Re: Keystone RV Company
Defect and Non-Compliance Report

SERVICE ADVISORY # 09-119

Hornet Propane Lines

Models Included: 2010 Hornet 32 RLSS Travel Trailers

Fig.1

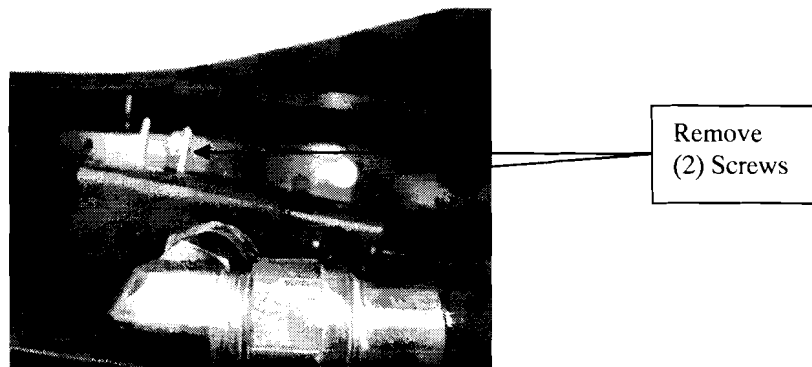
- Step 1.** Locate and remove the two screws holding the slideout LP manifold bracket from the slide out room bar. See Figure 1

Fig. 2 (before)

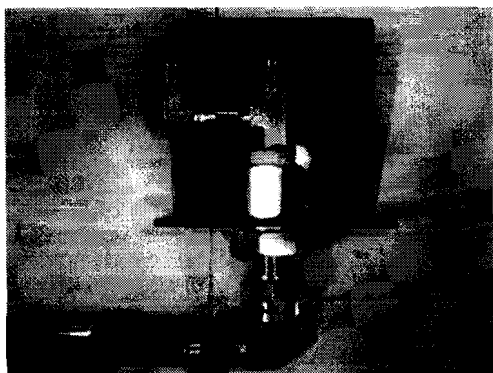
- Step 3.** Loosen the bulk head nut, and manifold inlet elbow. Rotate the inlet elbow 180 degrees, and the LP manifold 180 degrees, tighten both fittings. See figure 2 (before) and figure 3 (after).
- Step 4.** Reassemble the LP manifold to the stove and refrigerator copper lines.
- Step 5.** Secure the LP manifold bracket to the slideout room bar in the new location. The bracket will be located approximately 2" to rear from the original location.
